MITIGATION PLAN

CARPENTER BOTTOM MITIGATION SITE

Re: NCIRT Review and USACE Approval of the NCDMS Carpenter Bottom Mitigation Site /
Buncombe Co./ SAW-2018-02062/ NCDMS Project # 100090

SUBJECT: Carpenter Bottom Mitigation Project - NCIRT Comments during 30-day Mitigation Plan Review

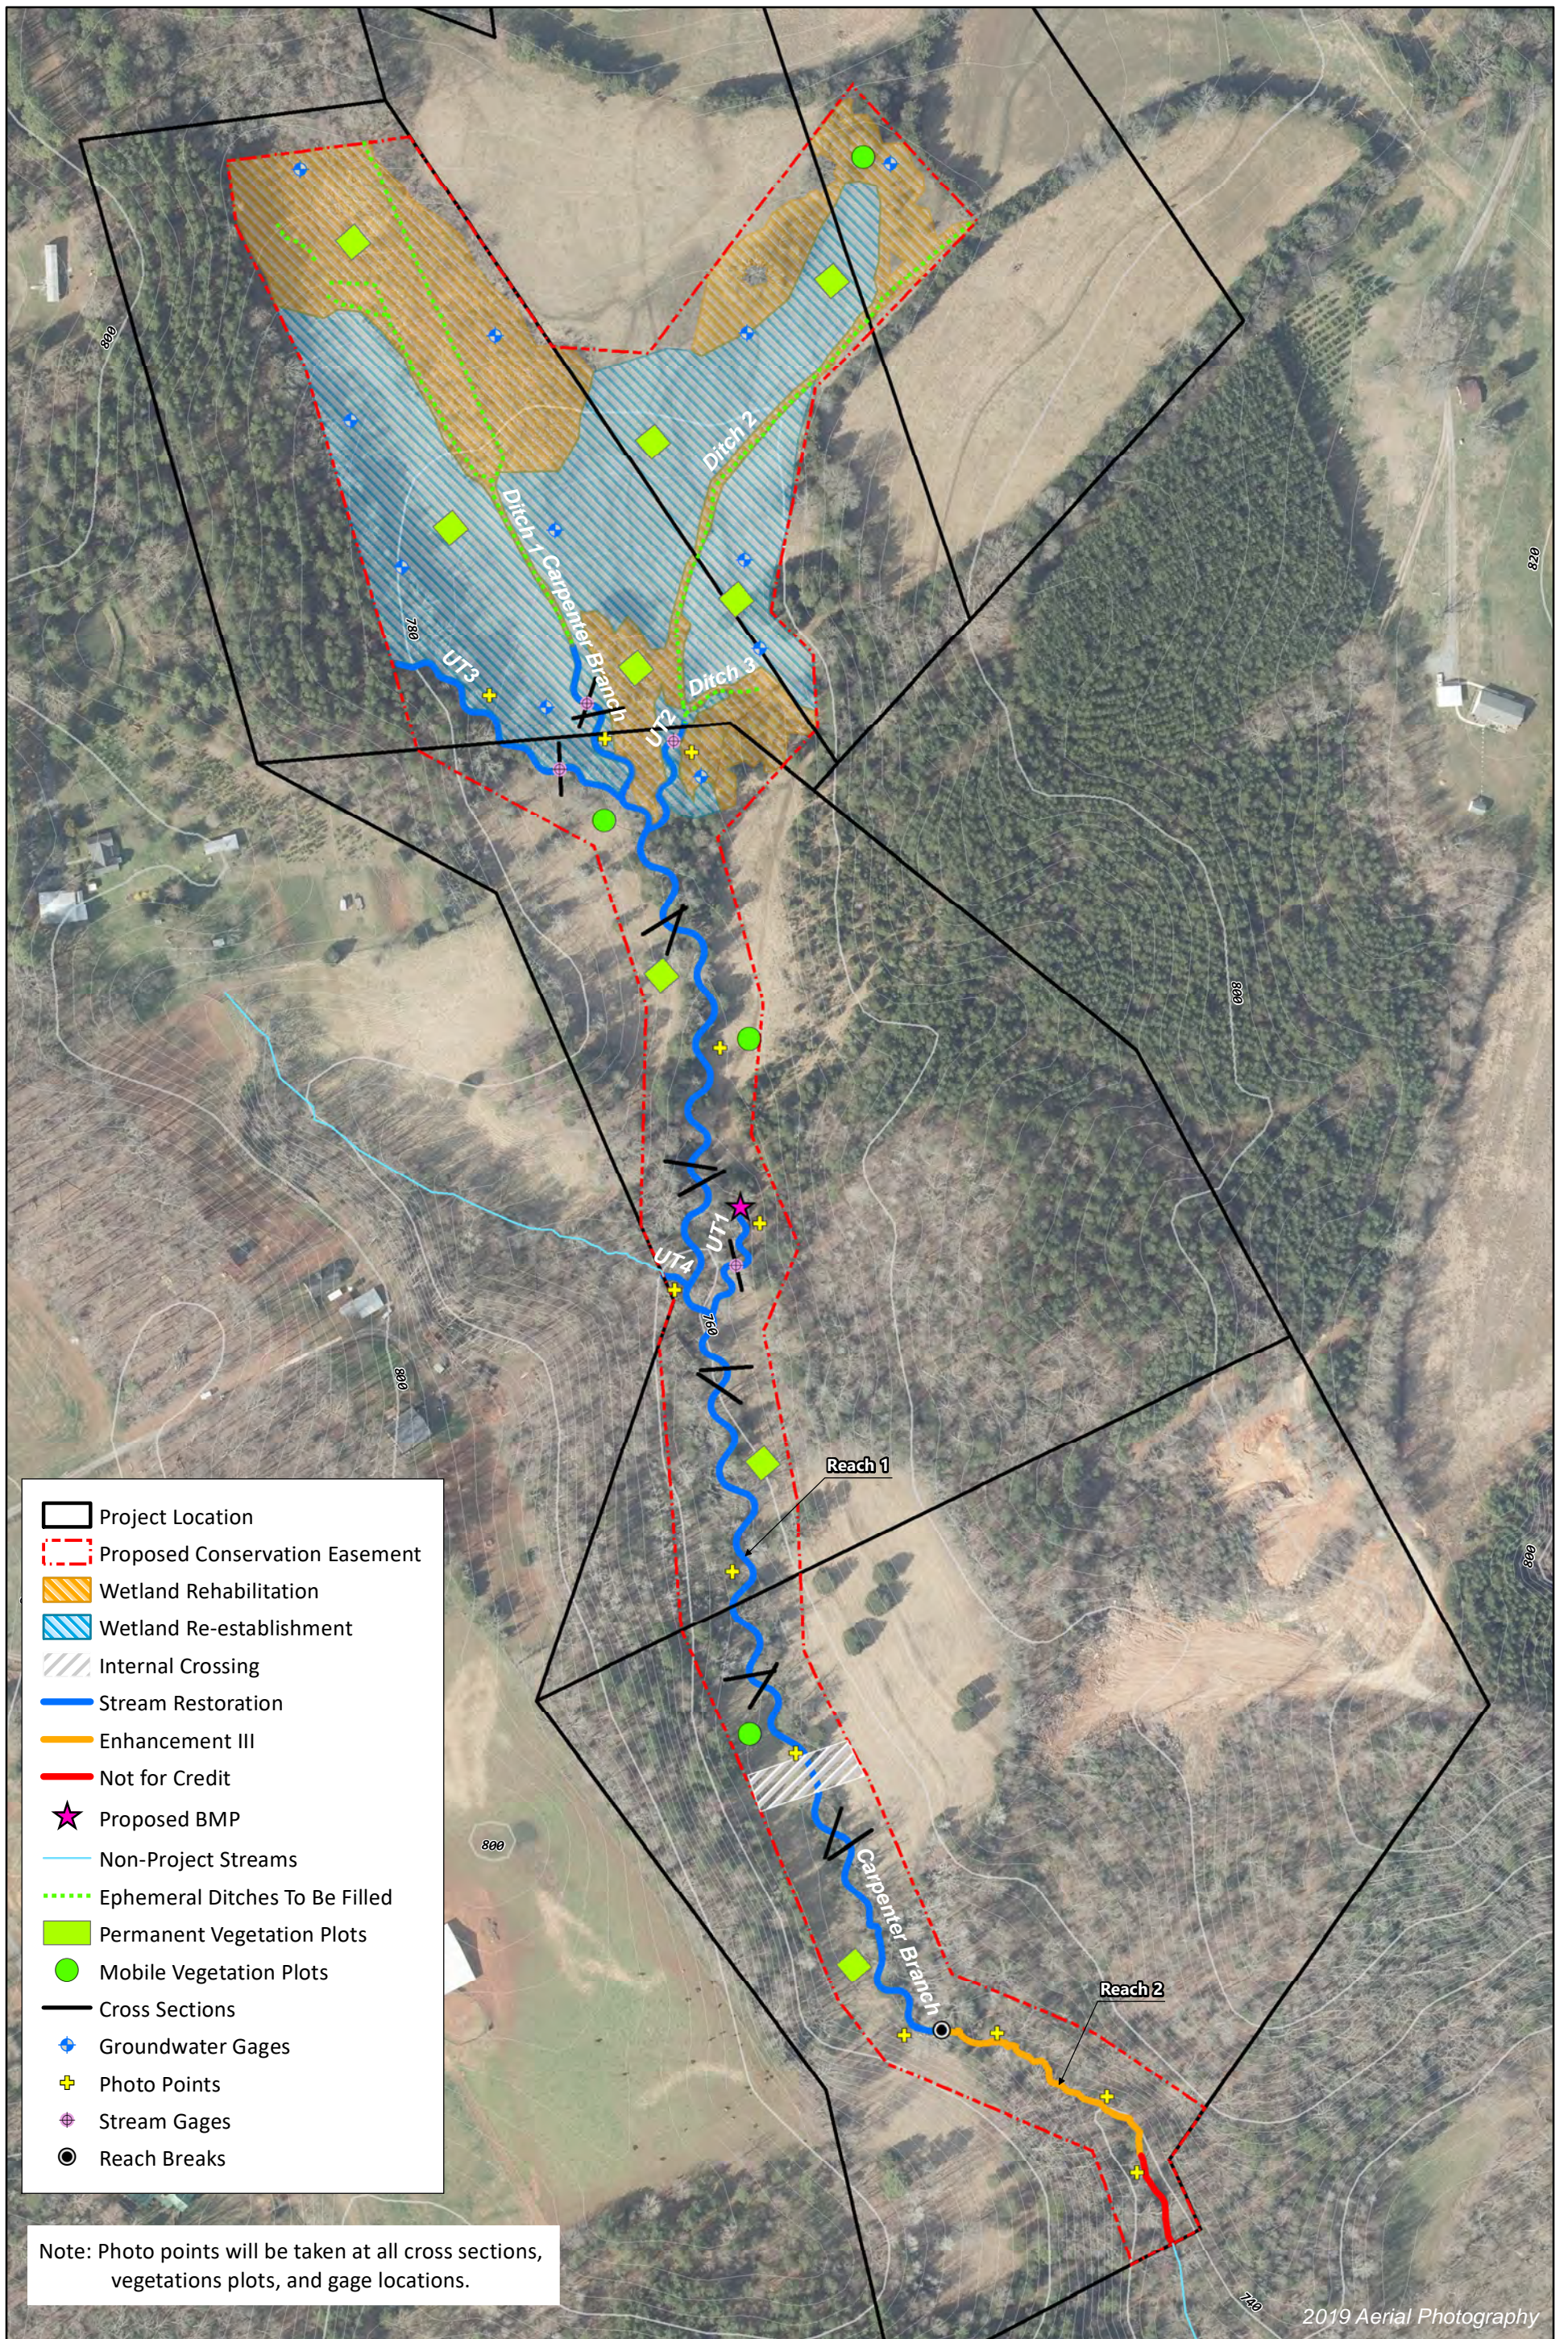
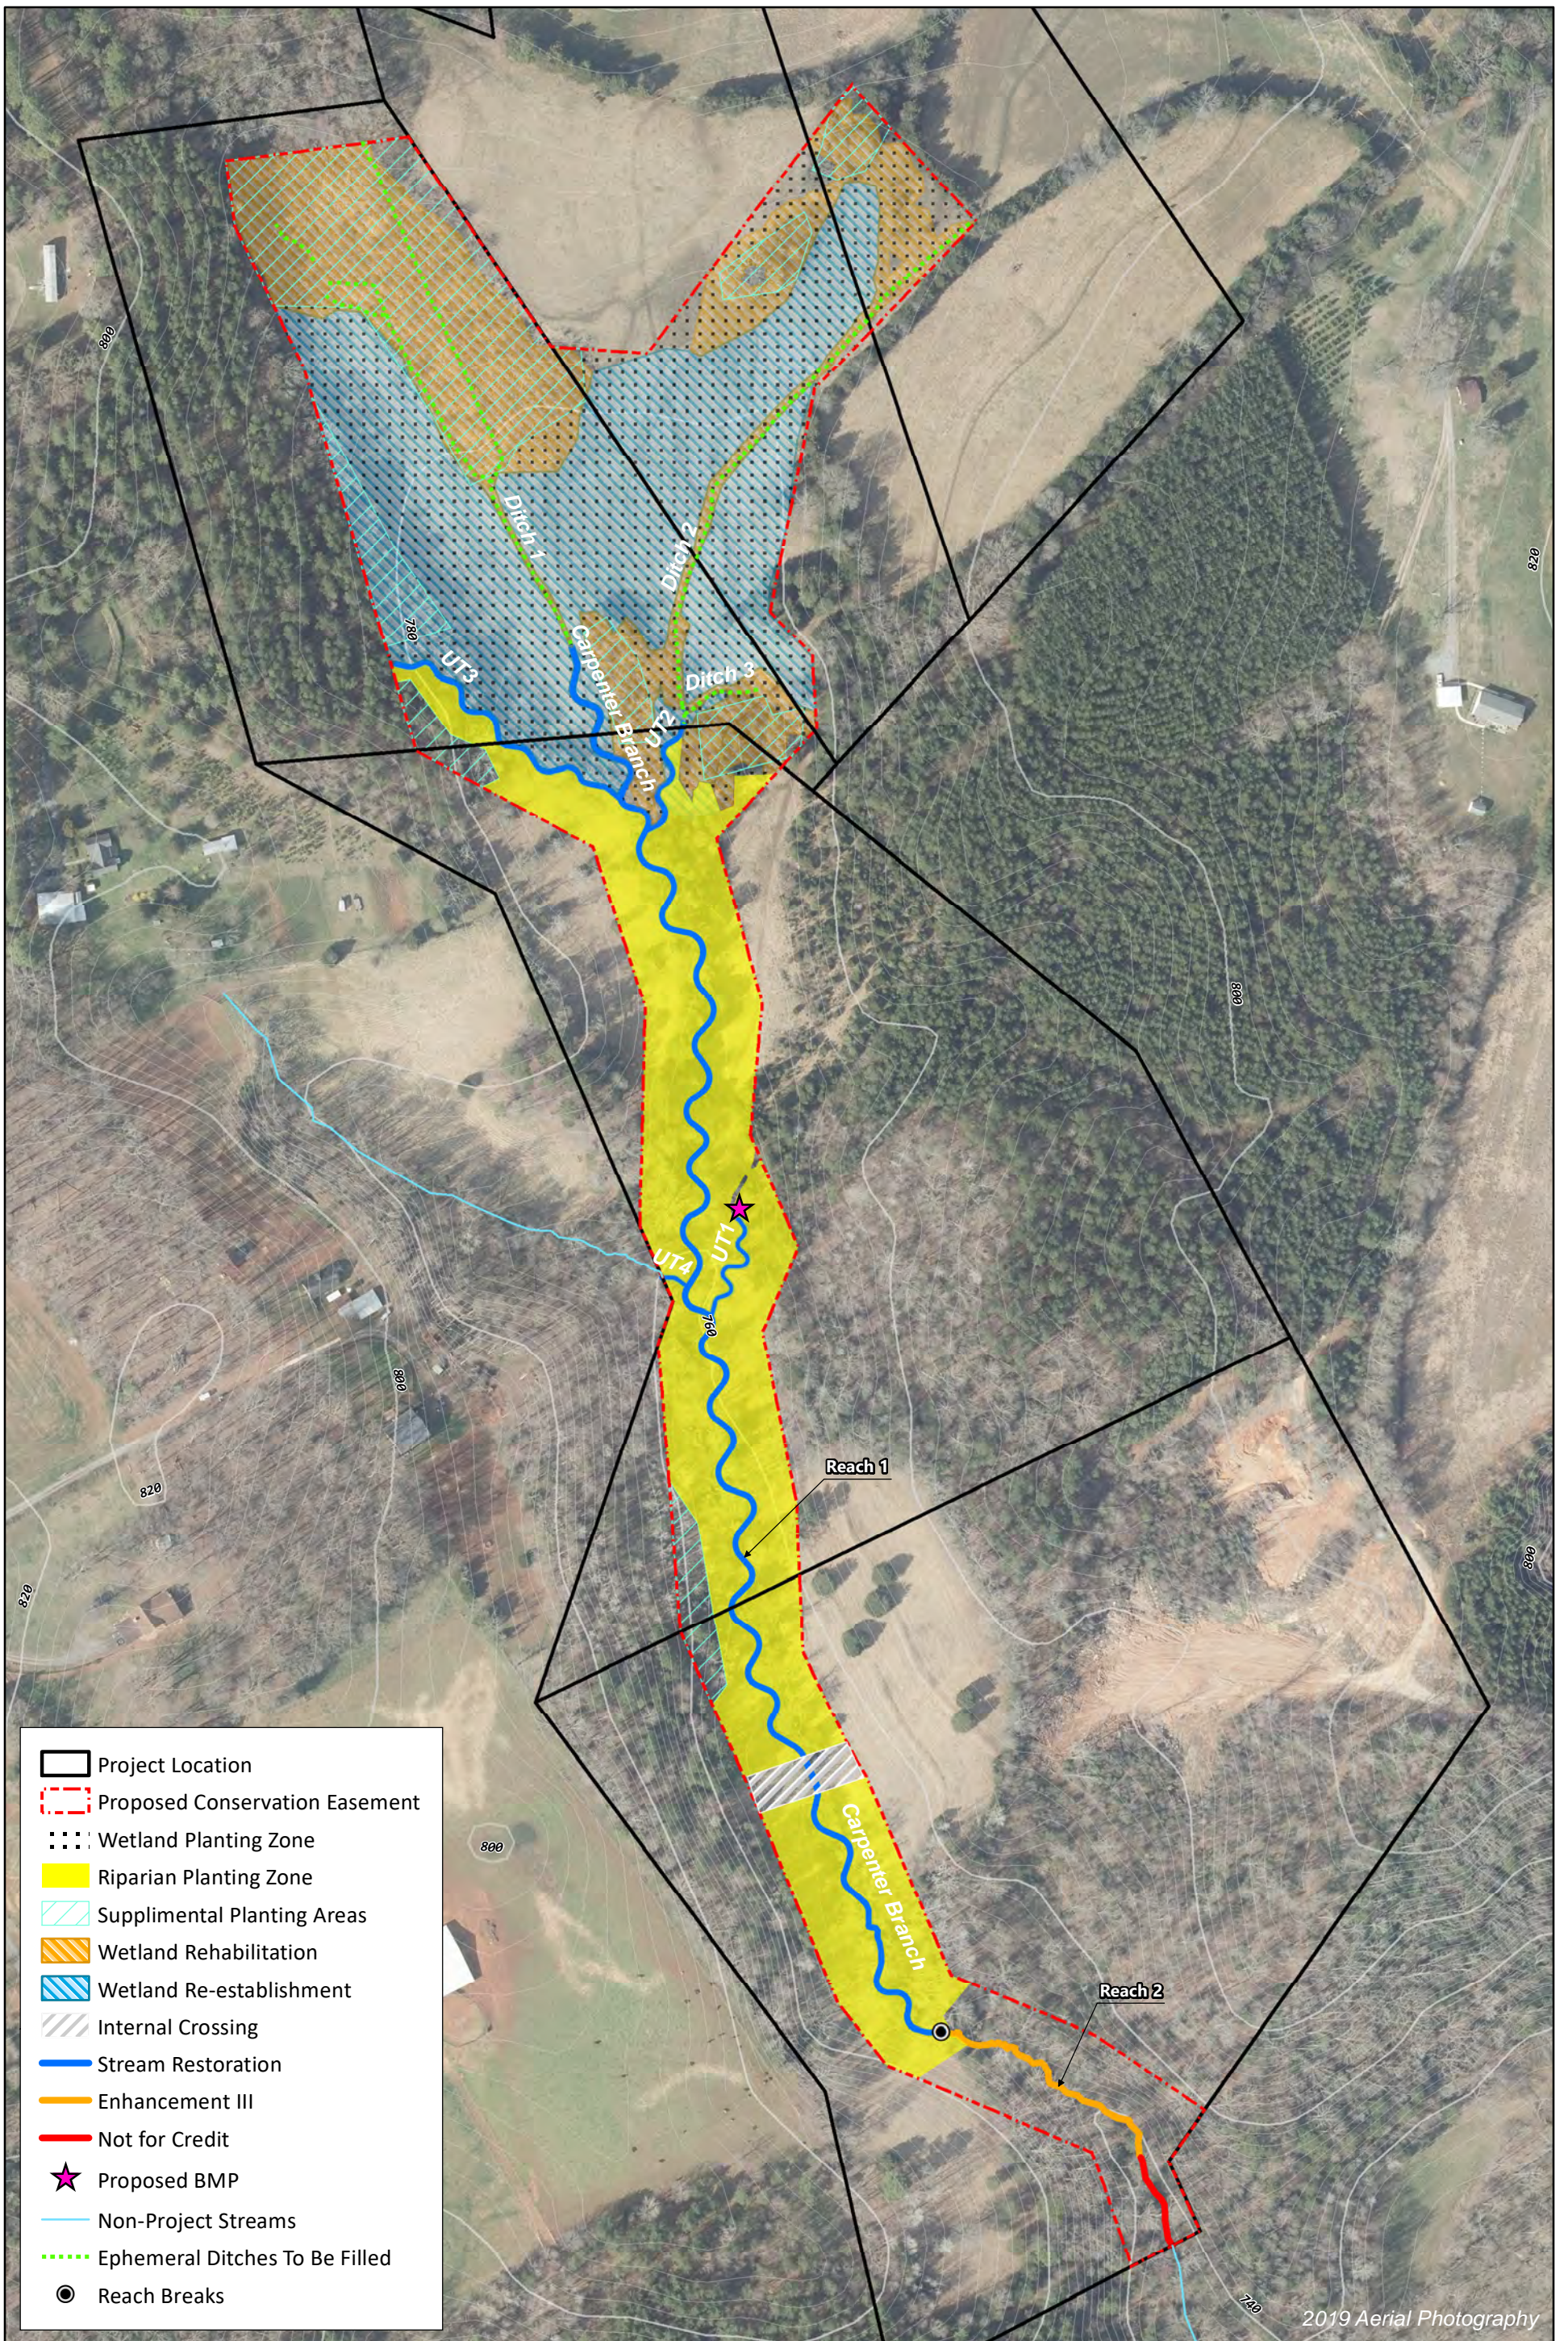
13. Figure 10 –
 - a. DWR requests the flow gauges on UT 3 and Carpenter Branch be shifted upstream near the proposed photo points (approximately two-thirds the way upstream of the confluence).

13. *Figure 10 –*

Wildlands Response: A permanent Vegetation plot was added to wetland rehabilitation areas within wetlands I & N. A mobile plot will be located in wetland M during monitoring. These changes can be seen on the revised Figure 10.

Wildlands Response: Flow gauges on UT3 and Carpenter Branch were shifted upstream. See new placement on the revised Figure 10.

Wildlands Response: A photo point was added at the proposed crossing. Figure 10 and Table 18 were revised accordingly.

Wildlands Response: The four random vegetation plots were added to Figure 10.

Wildlands Response: A note added to Figure 10 indicating that photo points will be taken at cross sections, veg plots and gauge locations.
